REPORT & RECOMMENDATIONS  
ON UNDERWATER DAMAGE ASSESSMENT  
PIER LIMA  
NAVAL STATION, GUANTANAMO BAY, CUBA

October 2, 1979

Re: Contract No. N624477-79-C-0387  
Inspection of Piling, Pier Lima,  
Naval Station, Guantanamo Bay,  
Cuba

Relative to our final report, on above referenced project,  
dated September 1979, please note the following erratum  
and/or changes:

FIGURE 2  
ALTERNATE PILE REPAIR  
BY INISWELL INC

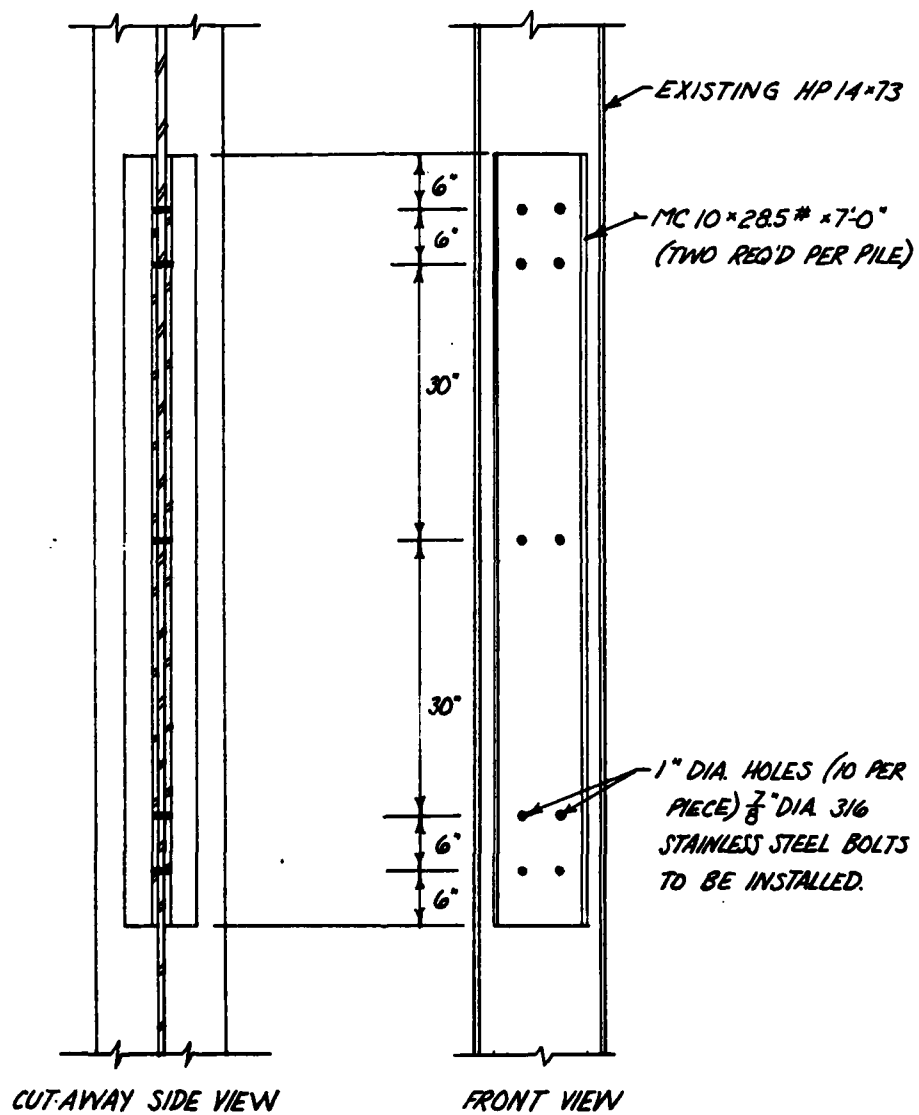
1. Page 14, line 23...delete "stainless"
2. Page 18...delete "316 stainless"
3. Page A-17, line 1...change "Fasteners"  
to "Bolts"
4. Page A-18 should have been transposed with  
page A-21 (i.e. bents 51-55 should have  
been in the beginning of the appendix).
5. Page A-25, line 1...change "BJD" to "DBJ"
6. The last two pages, the reference page  
and the bibliography page should have been  
bound between p. 23 and the Appendix 1  
title page.

1. P. 14, 3rd #, 4th line — delete the word "stainless."
2. P. 18, Fig. 2, notation for bolts, delete the words "316 stainless"
3. P. A-25 change "BJD" at top of sheet to "DBJ".
